# CITY OF ALBUQUERQUE

**Re: Marble Brewery**  
**9904 Montgomery Blvd., NE**  
**Traffic Circulation Layout**  
Engineer's/Architect's Stamp **NO STAMP** (G21-D043)

Based upon the information provided in your submittal received 3-4-16, the above referenced plan cannot be approved for Building Permit until the following comments are addressed:

TRAFFIC CIRCULATION LAYOUT

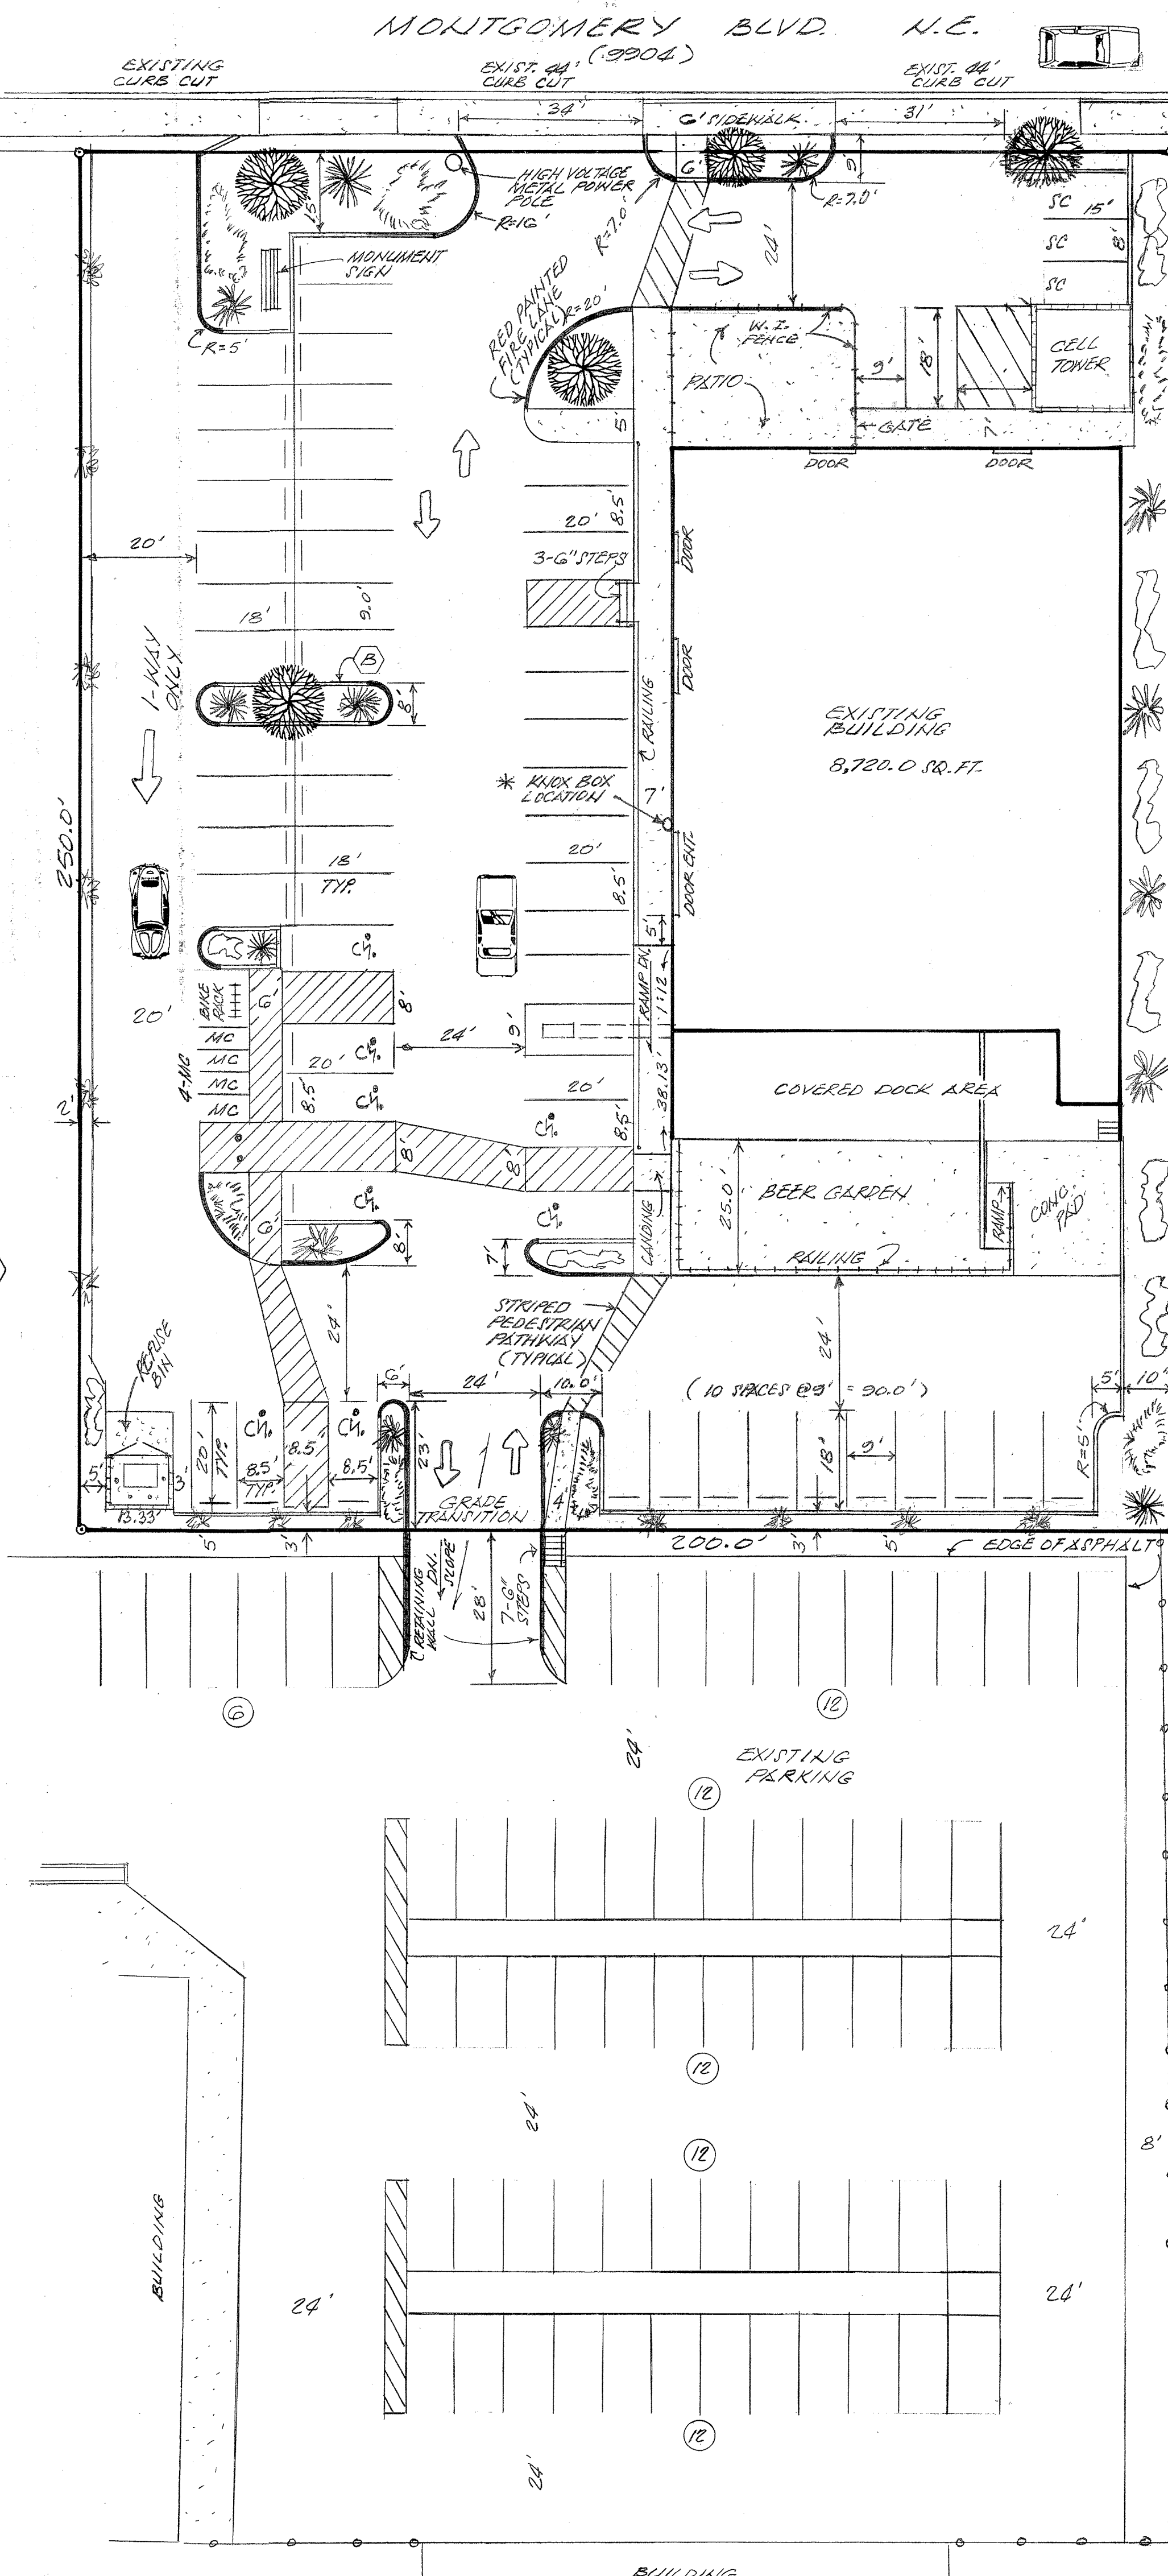
1. The traffic circulation layout must be stamped, signed, and dated by an engineer or architect licensed in the state of New Mexico.
2. Please identify location of Fire Department connection. If located on side of building, an access isle must be provided and no parking allowed in front of connection site.

3. Identify all existing access easements and rights of way with dimensions.
4. Identify the right of way width, medians, curb cuts, and street widths on Montgomery Blvd.

5. Please detail ADA ramp to building entrance, along with all building or patio entrances.
6. Please list the width and length for all existing and proposed parking spaces.

7. Label the compact parking spaces by placing the words "**COMPACT**" on the pavement of each space.
8. The ADA accessible parking sign must have the required language per 66-7-352.4C NMSA 1978 "**Violators Are Subject to a Fine and/or Towing.**" Please call out detail and location of HC signs.

9. The ADA access aisles shall have the words "**NO PARKING**" in capital letters, each of which shall be at least one foot high and at least two inches wide, placed at the rear of the parking space so as to be close to where an adjacent vehicle's rear tire would be placed. (66-1-4.1.B NMSA 1978)

10. Provide a min 6" or max 8" high concrete barrier curb or other acceptable barrier between landscaping and parking areas and/or drive aisles. Please call out detail and location of barrier curb.

11. Service vehicle and/or refuse vehicle maneuvering must be contained on-site; provide a copy of refuse approval.
12. One-way vehicular paths require pavement directional signage and a posted **"Do Not Enter"** sign at the point of egress. Please show detail and location of posted signs.

13. It is not apparent what type of pavement surface is being proposed. A hard driving surface will be required as part of this proposed project for parking area and drive aisles.

14. Please provide a sight distance exhibit (see the *Development Process Manual, Chapter 23, Section 3, Part D.5 Intersection Sight Distance*). Please show this detail for all entrances/exits on Montgomery Blvd.

15. Please add the following note to the clear sight triangle: "Landscaping and signage will not interfere with clear sight requirements. Therefore, signs, walls, trees, and shrubbery between 3 and 8 feet tall (as measured from the gutter pan) will not be acceptable in this area."

16. Please include a copy of your shared access agreement with the adjacent property owner.
17. On-Street parking Allowance to fulfill zoning's parking requirement must be requested and approved by the Traffic Engineer, Racquel Michel prior to TCL approval. The application requires at least 30 working days. On-street parking allowances are based on available parking along public right-of-ways fronting the property. The business will only be granted 50% credit for available street parking.

18. Unused curb cuts must be replaced with sidewalk and curb & gutter. A build note must be provided referring to the appropriate City Standard drawing.

19. All broken or cracked sidewalk must be replaced with sidewalk and curb & gutter. A build note must be provided referring to the appropriate City Standard drawing.
